State of New Mexico
Energy, Minerals and Natural Resources

SUNDRY NOTICES AND REPORTS ON WELLS (DO NOT USE THIS FORM FOR PROPOSALS TO DRILL OR TO DEEPEN OR PLUG BACK TO A DIFFERENT RESERVOIR. USE "APPLICATION FOR PERMIT" (FORM C-101) FOR SUCH PROPOSALS.)		WELL API NO. 30-015-00604

2. Name of Operator Percussion Petroleum Operating, LLC		6. State Oil & Gas Lease No. VA-0787-0003
3. Address of Operator 919 Milam, Ste.2475, Houston, TX 77002		7. Lease Name or Unit Agreement Name Chalk Bluff State SWD

This sundry requests and documents an error on the approved C-101 as follows:

WELL SCHEMATIC - PROPOSED Chalk Bluff State SWD No.1

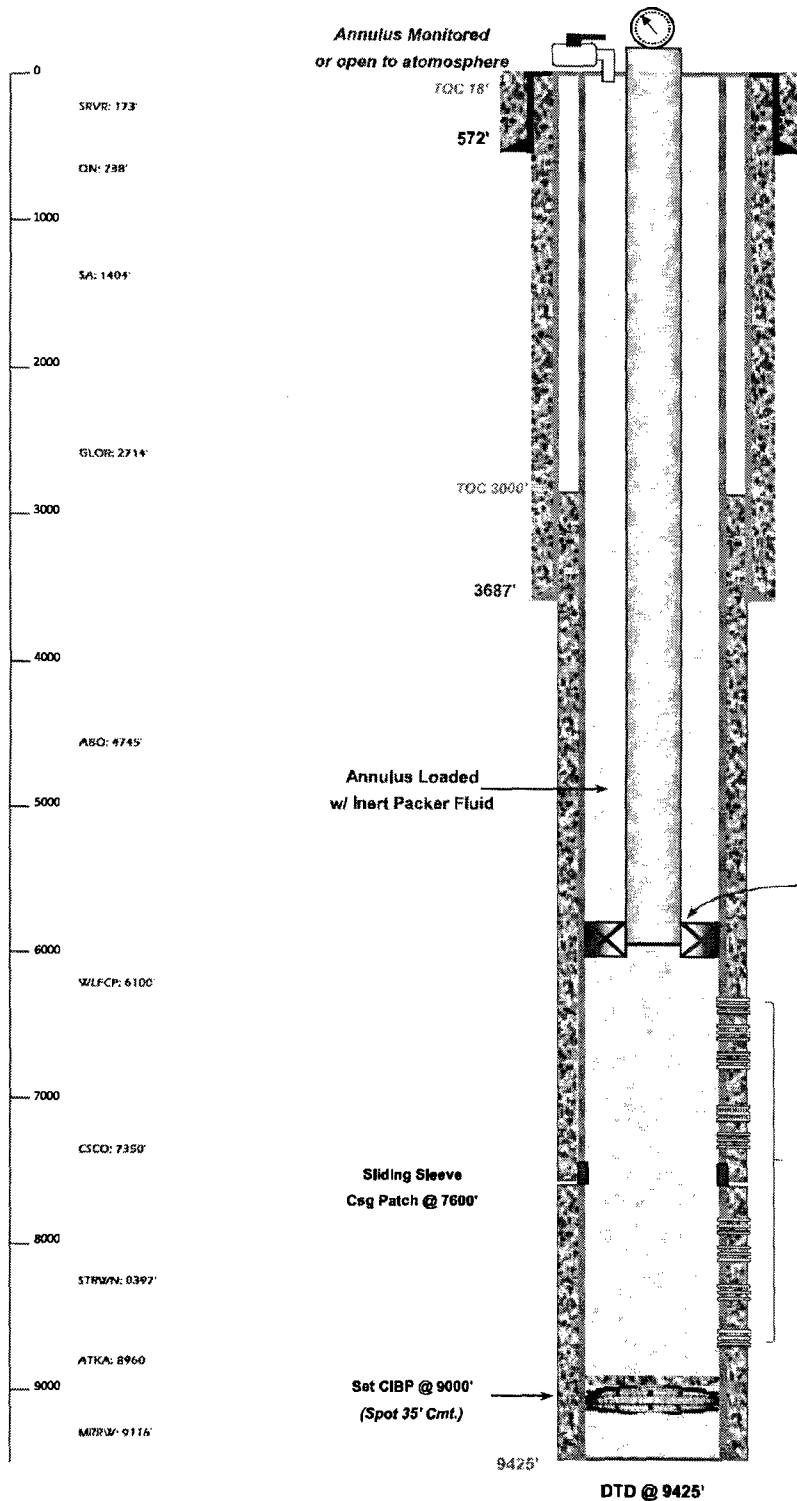
The Top of Cement on the new string of 5.5" will be brought up to ~3000' and verified by CBL.

NEW Production Casing
5.5", 17.0# (8.75" Hole) @ 7600'
1100 sx - TOC @ 3000' by Calc.
